Access Compliance Report

Public Rights-of-Way

(Curb Ramps)

Intersection ID: 12045	Main Street: HARLEE_AV	Cross Street: OLD_DOWD_RD	Location:	N
ADA ID: 2C51CB3F7DDF	Ramp Type: Perp	Initial Pass/Fail: Fail	Overall Compliance: No	Severity Score: 26.25

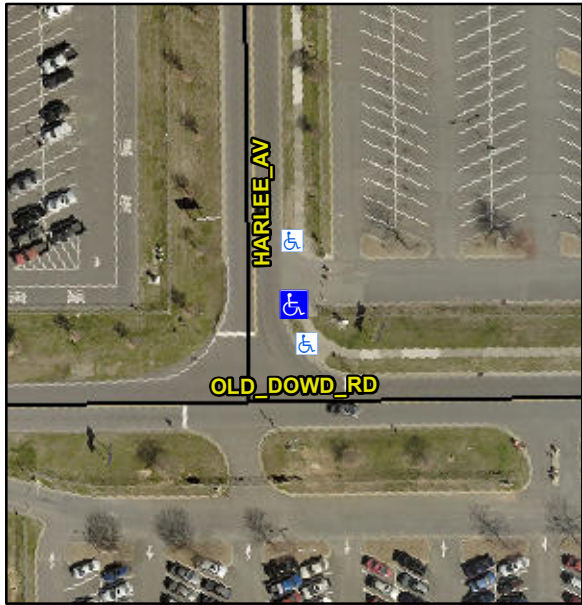
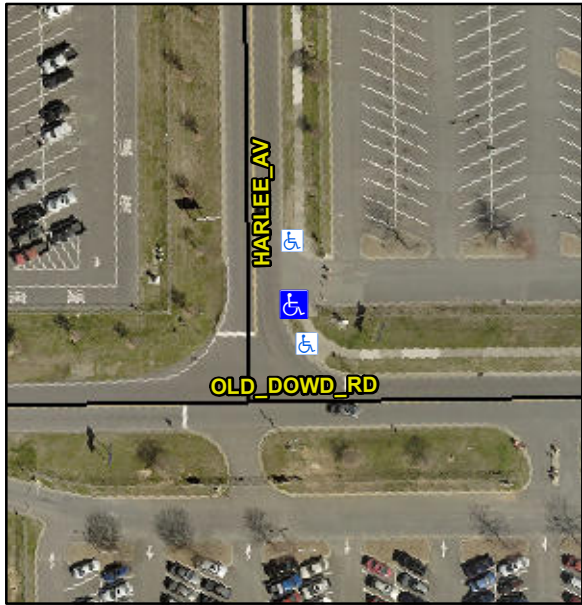
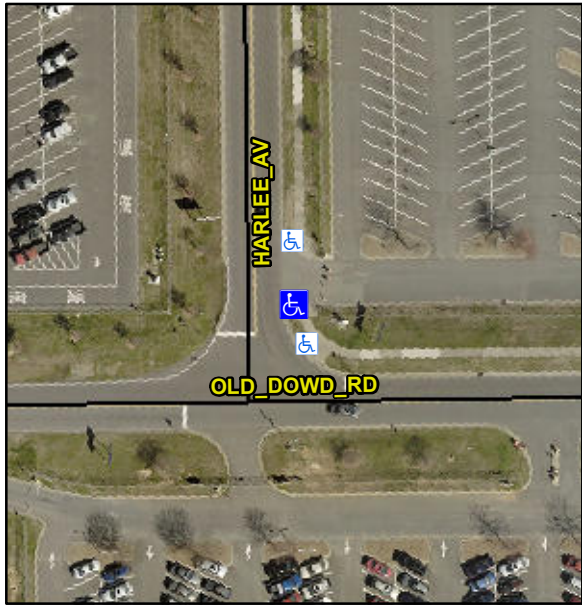
Codes/Mitigation Info/Possible Solution			Field Measurements/Component Compliance					
	Possible Solutions:		Compliance	Description	Data	Compliance	Description	Data
	Remove & Replace Entire Ramp.		N/A	Ramp Length (in)	60.0	No	Ramp Slope (%)	12.3
			Yes	Ramp Width (in)	48.0	No	Ramp XSlope (%)	4.6
			N/A	Flare Type LT	N/A	N/A	Flare Type RT	N/A
			N/A	Flare Slope LT (%)	N/A	N/A	Flare Slope RT (%)	N/A
			N/A	Flare Traversable LT?	N/A	N/A	Flare Traversable RT?	N/A
			N/A	Landing Length (in)	N/A	N/A	DWS Provided?	N/A
			N/A	Landing Width (in)	N/A	N/A	DWS Contrast?	N/A
			N/A	Landing Slope (%)	N/A	N/A	DWS Length (in)	N/A
			N/A	Landing X Slope (%)	N/A	N/A	DWS Full Width?	N/A
	Surveyor Notes:		N/A	Landing Curb? (Y/N)	N/A	N/A	DWS Offset (in)	N/A
			N/A	Shared Landing?	N/A			
			N/A	Gutter Ponding?	N/A	N/A	Gutter Slope (%)	N/A
			N/A	Gutter Lip Ht (in)	N/A	N/A	Gutter X Slope (%)	N/A
			N/A	Painted X Walk1?	No	N/A	Painted X Walk2?	N/A

X Walk 1 Direction	To N		X Walk 2 Direction	N/A
			N/A	X Walk 1 Width (in)	N/A	N/A	X Walk 2 Width (in)	N/A
				X Walk 1 Slope (%)	0.2		X Walk 2 Slope (%)	N/A
				X Walk 1 X Slope (%)	3.7		X Walk 2 X Slope (%)	N/A
			N/A	Ramp inside XWalk1?	N/A	N/A	Ramp inside XWalk2?	N/A
	PROW/ADA:			Road Slope (%)	N/A	N/A	Clear Space?	N/A
				Road X Slope (%)	N/A	N/A	Clear Space to XWalk (in)	N/A
			N/A	Any Obstructions?	N/A	N/A	Storm Grate/Utility Hazard?	N/A
				Obstruction Type			Storm Grate/Utility Type	
						N/A		N/A
						Yes	Surface Condition? (G/P)	Good

R304.2.2, R304.5.3

Remove & Replace Entire Ramp.
